Access Compliance Report

Public Rights-of-Way

Intersection ID: 31419	Main Street: CORNELIA_DR	Cross Street: OLD_WAGON_RD	Location: NW
ADA ID: AF5A0E82377A	Ramp Type: PerpDiag	Initial Pass/Fail: Fail	Overall Compliance: No
			Severity Score: 21.25

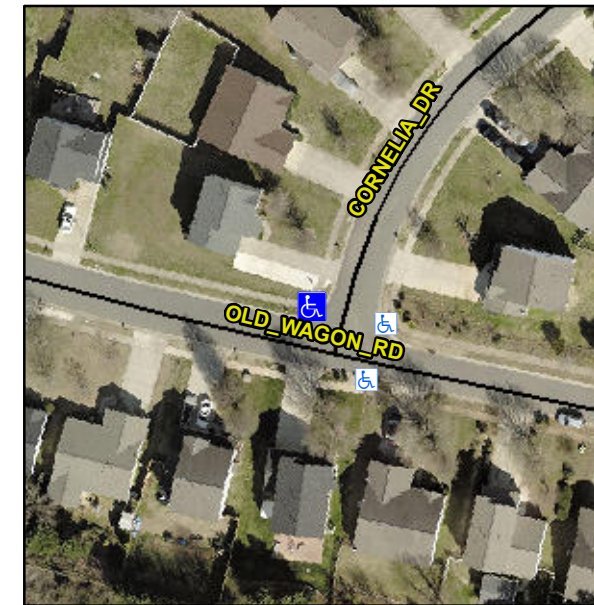
R304.5.1, R304.2.2

Compliance	Description	Data	Compliance	Description	Data
N/A	Ramp Length (in)	48.5	No	Ramp Slope (%)	8.4
No	Ramp Width (in)	42.0	Yes	Ramp XSlope (%)	1.5
N/A	Flare Type LT	N/A	N/A	Flare Type RT	N/A
N/A	Flare Slope LT (%)	N/A	N/A	Flare Slope RT (%)	N/A
N/A	Flare Traversable LT?	N/A	N/A	Flare Traversable RT?	N/A
N/A	Landing Length (in)	N/A	N/A	DWS Provided?	N/A
N/A	Landing Width (in)	N/A	N/A	DWS Contrast?	N/A
N/A	Landing Slope (%)	N/A	N/A	DWS Length (in)	N/A
N/A	Landing X Slope (%)	N/A	N/A	DWS Full Width?	N/A
N/A	Landing Curb? (Y/N)	N/A	N/A	DWS Offset (in)	N/A
N/A	Shared Landing?	N/A			
N/A	Gutter Ponding?	N/A	N/A	Gutter Slope (%)	N/A
N/A	Gutter Lip Ht (in)	N/A	N/A	Gutter X Slope (%)	N/A
N/A	Painted X Walk1?	No	N/A	Painted X Walk2?	No
	X Walk 1 Direction	To S		X Walk 2 Direction	To E
N/A	X Walk 1 Width (in)	N/A	N/A	X Walk 2 Width (in)	N/A
	X Walk 1 Slope (%)	6.9		X Walk 2 Slope (%)	6.0
	X Walk 1 X Slope (%)	1.6		X Walk 2 X Slope (%)	4.3

Remove & Replace Curb Ramp With Two New Directional Ramps or Equivalent.
